**APPLICATION FOR FINAL RESUBDIVISION APPROVAL
43 GATES FARM ROAD-2 LOT RESUBDIVISION
MEETING DATE : DECEMBER 12, 2023**

**PUBLIC HEARING # 3
12/12/23 AGENDA**

Re: 43 Gates Farm Road Re-subdivision

The Engineering Division has reviewed plans for the proposed re-subdivision of land at 43 Gates Farm Road prepared by Megson, Heagle, and Friend Civil Engineers and Land Surveyors, LLC including plans revised November 15, 2023 and offers the following comments:

EROSION & SEDIMENTATION NOTES & DETAILS #43 GATES FARM ROAD RESUBDIVISION PREPARED FOR BRYAN FEERY GLASTONBURY, CONN.

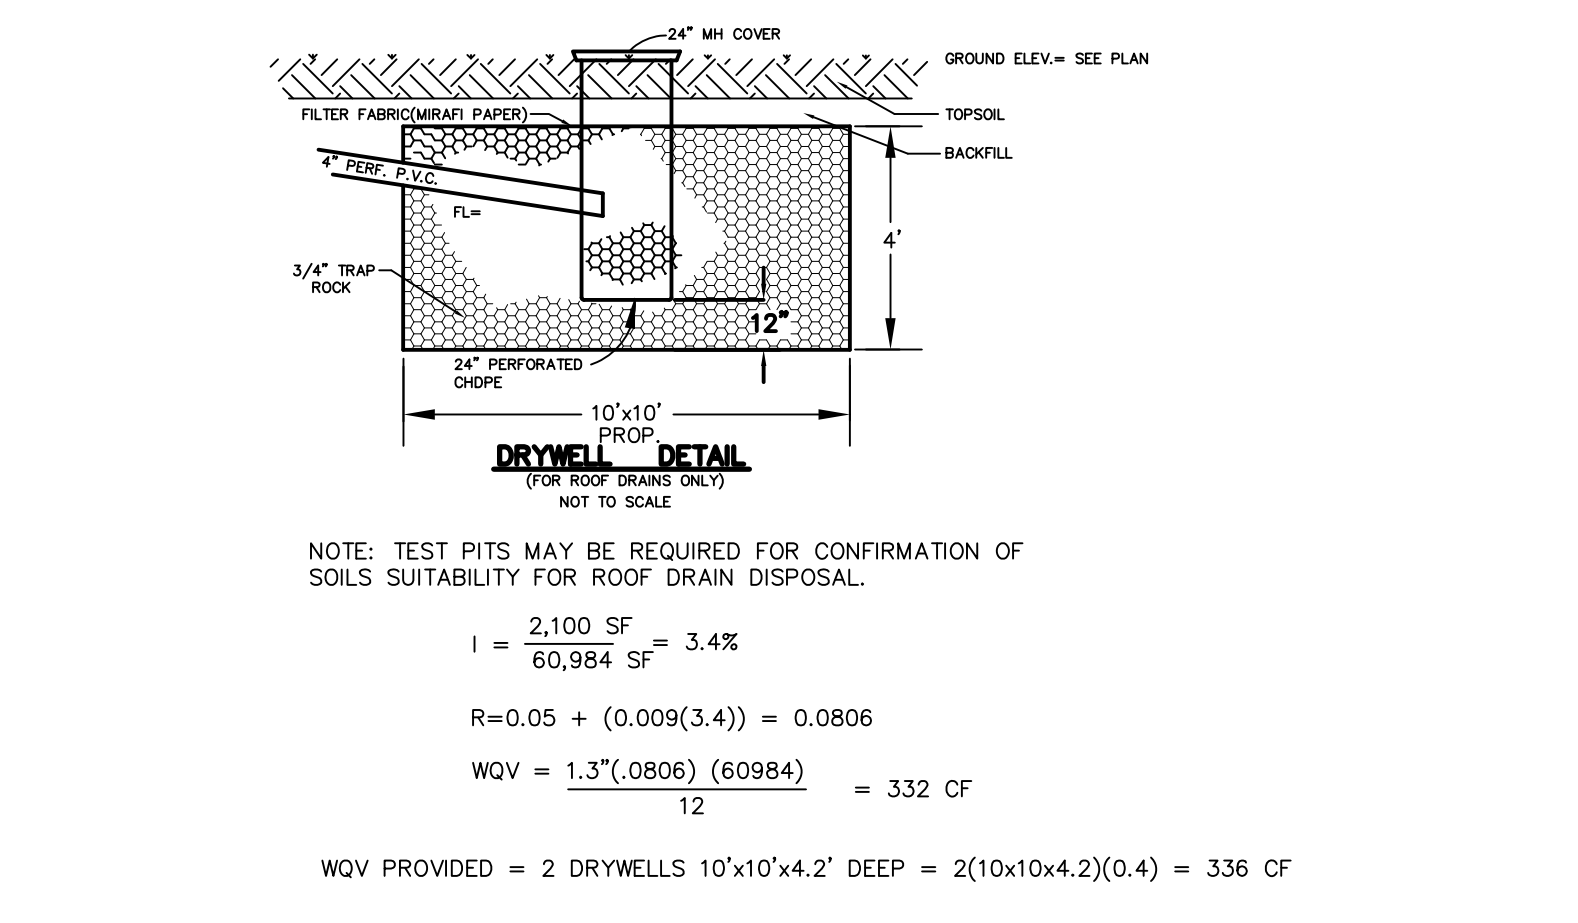
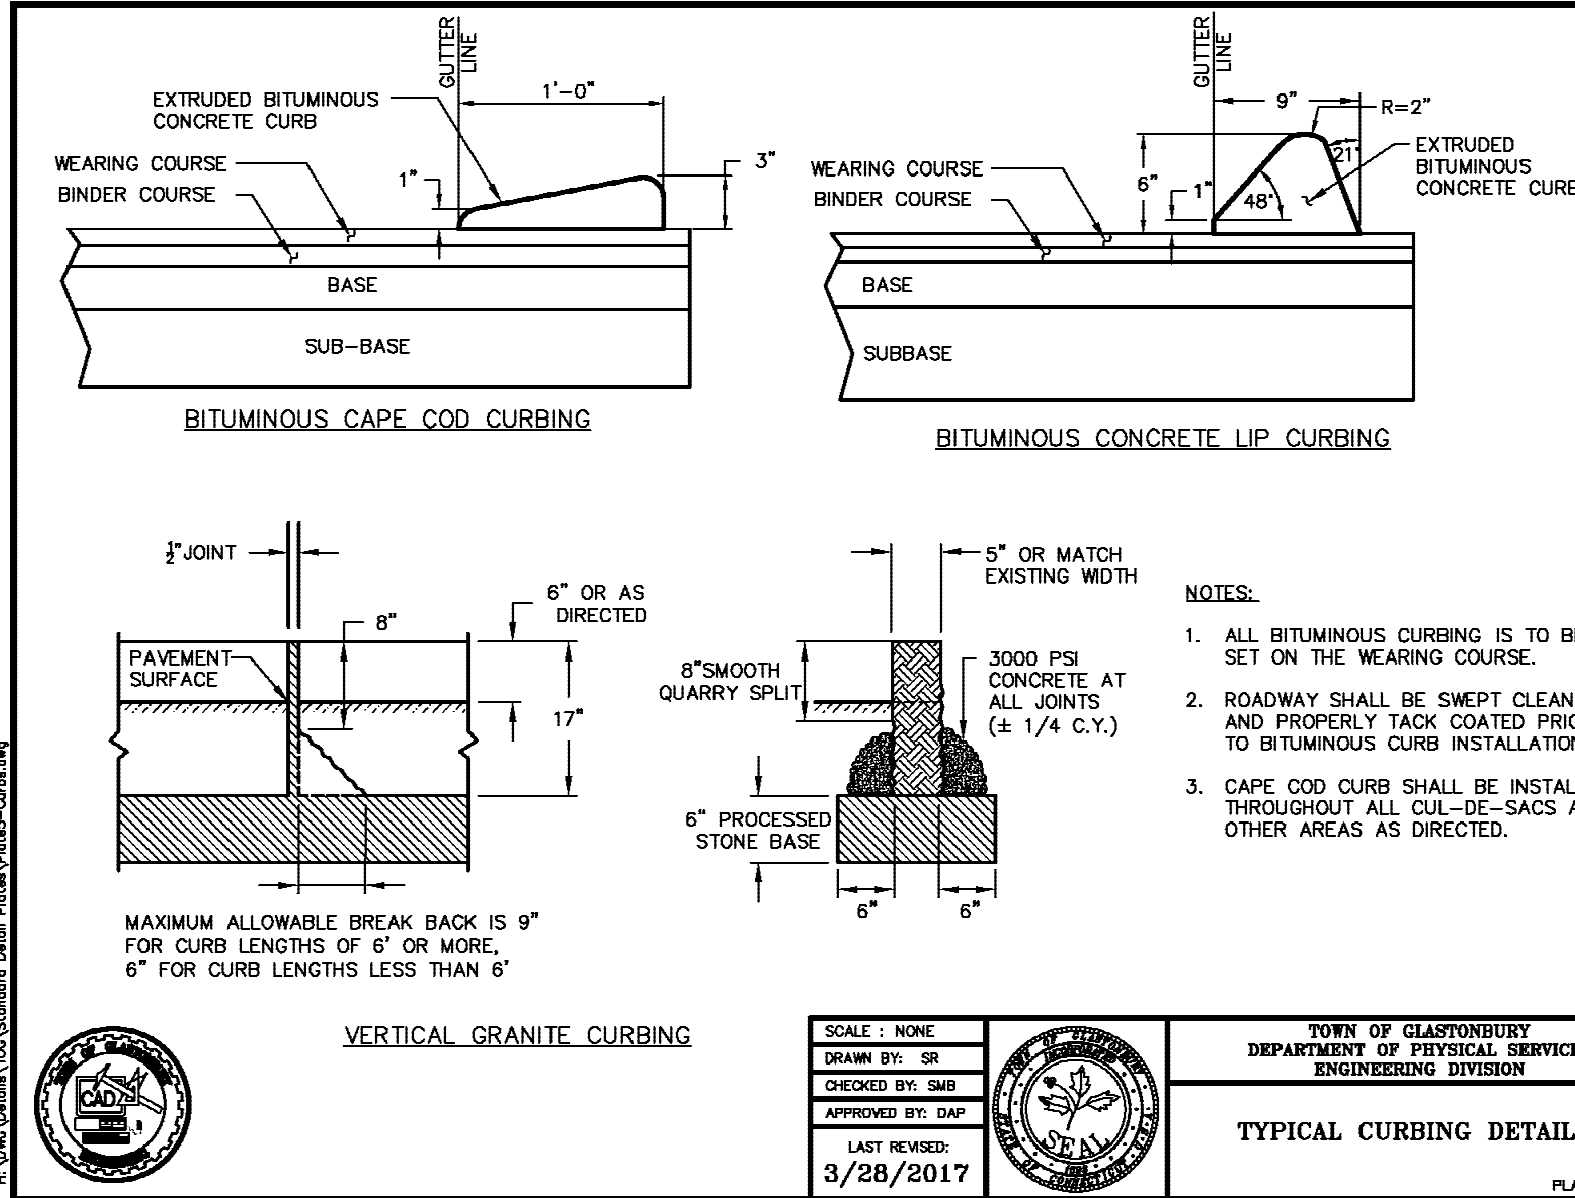
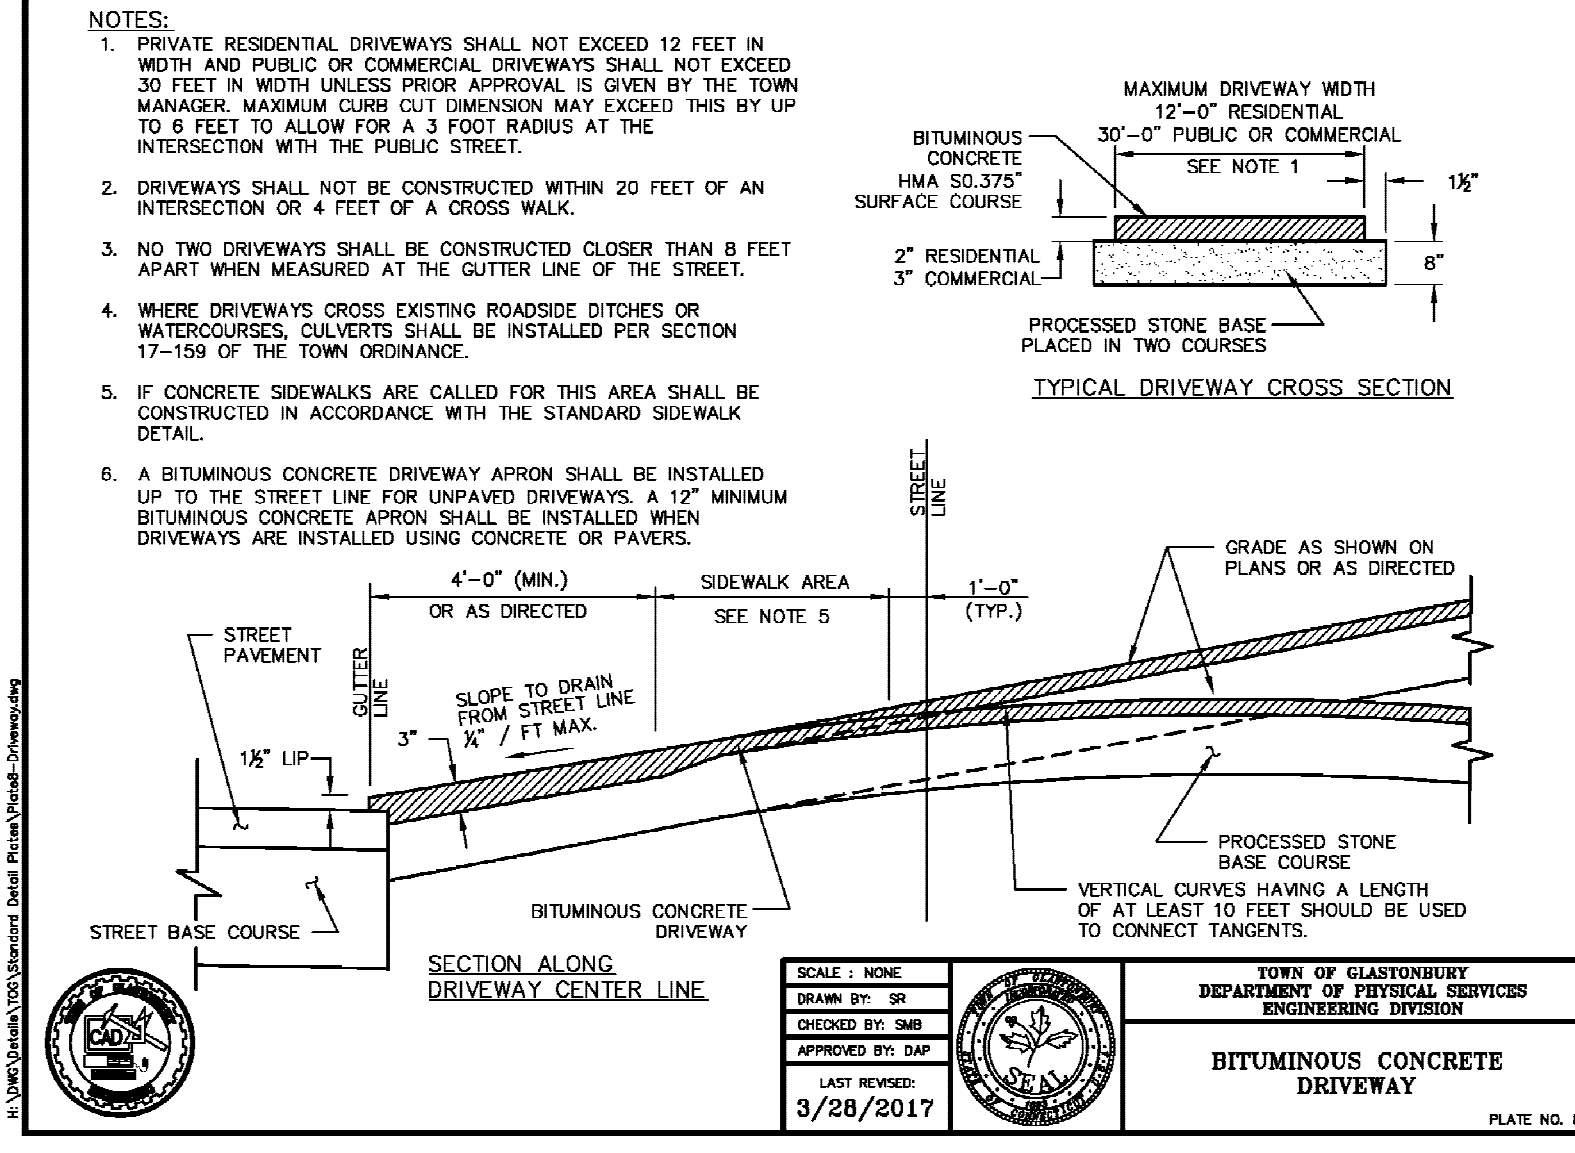
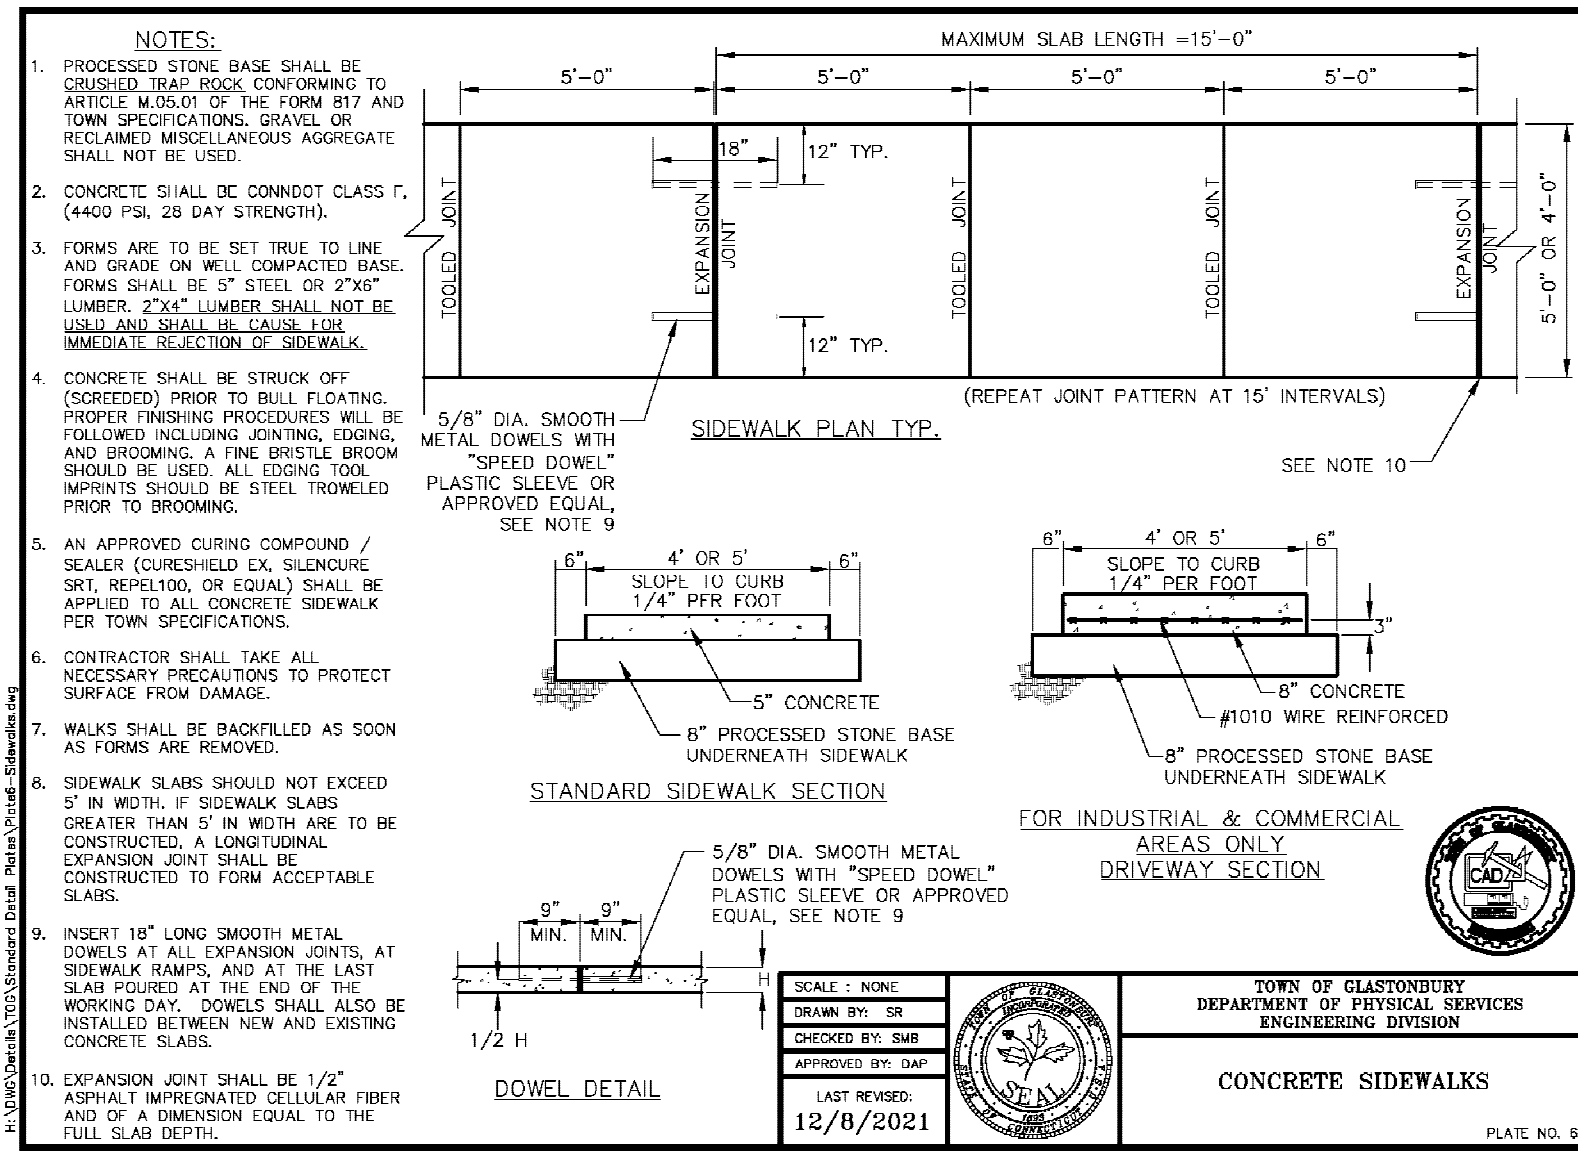
3. The stormwater system maintenance schedules on Sheets 6 and 7 need to state that such maintenance is the responsibility of the property owner. These maintenance narratives should be moved to the site plan to ensure that they are recorded on the land records.
